Access Compliance Report

Public Rights-of-Way (Curb Ramps)

Intersection ID: 10031808	Main Street: MILLENNIUM_AV	Cross Street: N/A	Location:	N
ADA ID: 6BB64E8484E6	Ramp Type: Directional1	Initial Pass/Fail: Pass	Overall Compliance: No	Severity Score: 5.25
Codes/Mitigation Info/Possible Solution		Field Measurements/Component Compliance

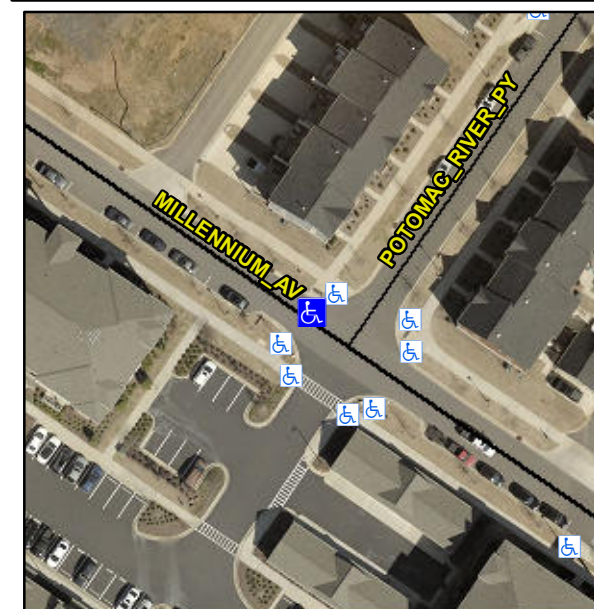
R304.5.3, R305.2, R304.5.4

Compliance	Description	Data	Compliance	Description	Data
N/A	Ramp Length (in)	68.0	Yes	Grade Break?	Yes
Yes	Ramp Width (in)	71.0	Yes	Grade Break Slope (%)	0.7
Yes	Ramp Slope (%)	3.1	Yes	Grade Break XSlope (%)	0.1
No	Ramp XSlope (%)	2.9			
Yes	Flare Type LT	N/A	Yes	Flare Type RT	N/A
N/A	Flare Slope LT (%)	N/A	N/A	Flare Slope RT (%)	N/A
N/A	Flare Traversable LT?	No	N/A	Flare Traversable RT?	No
Yes	Landing Length (in)	76.0	Yes	DWS Provided?	Yes
Yes	Landing Width (in)	71.0	Yes	DWS Contrast?	Yes
Yes	Landing Slope (%)	0.2	Yes	DWS Length (in)	24.0
No	Landing X Slope (%)	2.4	Yes	DWS Full Width?	Yes
N/A	Landing Curb? (Y/N)	No	Yes	DWS Offset LT (in)	25.0
N/A	Shared Landing?	Yes	No	DWS Offset RT (in)	7.0
Yes	Gutter Ponding?	No	No	Gutter Slope (%)	8.3
Yes	Gutter Lip Ht (in)	0.0	Yes	Gutter X Slope (%)	2.4
N/A	Painted X Walk1?	No		Road Slope (%)	4.0
	X Walk 1 Direction	To SW		Road X Slope (%)	2.4
	X Walk 1 Width (in)	N/A		Clear Space?	Yes

**Remove & Replace Entire Ramp.
Remove & Replace Gutter.**
